Docket Number:	03-AFC-02C
Project Title:	Los Esteros Phase II Compliance
TN #:	221243-2
Document Title:	Los Esteros Critical Energy Center Amendment Petition for Modification
Description:	Petition for Modification to add battery storage at the Los Esteros Critical Energy Facility
Filer:	Barbara McBride
Organization:	Calpine
Submitter Role:	Applicant
Submission Date:	9/19/2017 2:36:29 PM
Docketed Date:	9/19/2017

Petition for Modification

**Los Esteros Critical Energy
Facility, LLC**

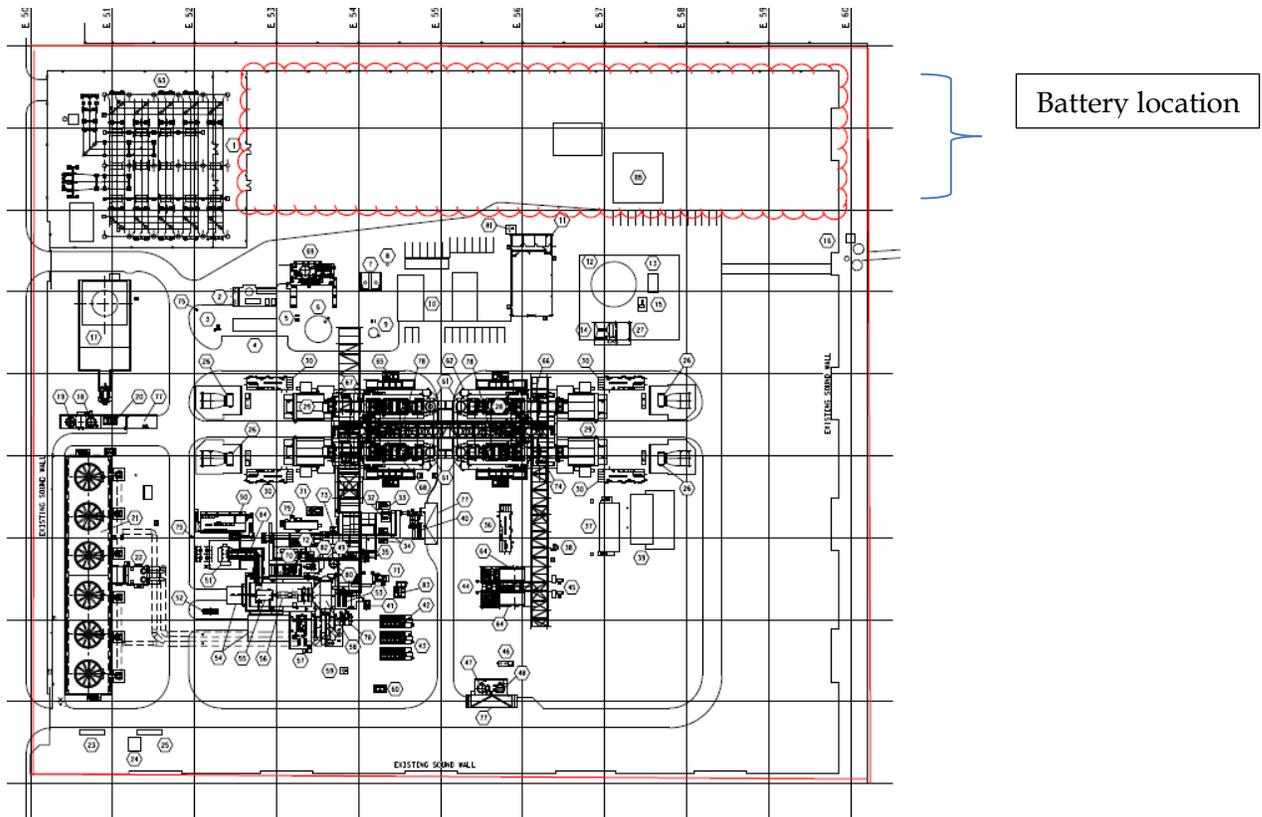
This section includes a description of the proposed project modifications, consistent with CEC Siting Regulations (Title 20, CCR, Section 1769 (a) (1) (A)). The battery installation will be located on the north end of the existing property east of the switchyard inside the fence line. The project map below indicates the area that the batteries will be located. The project includes an installation of up to 6 MW vanadium flow battery, with up to 18 MWh of energy storage capability and/or an additional installation of up to 6 MW lithium-ion (Li-ion) Battery, with up to 6 MWh of energy storage capability. These energy storage systems are comprised of the storage device, the interconnection and the communication system. The system layout will be approximately 167 ft. wide x 112 ft. length and approximately 20 ft. in height. The energy storage system will be located on a concrete foundation with secondary containment.

In addition, the project will include an interconnection of the battery to the existing 4160V auxiliary bus thru which energy will flow to and from the grid using existing electrical infrastructure and installation of a new and separate revenue meter for monitoring flow battery activity.
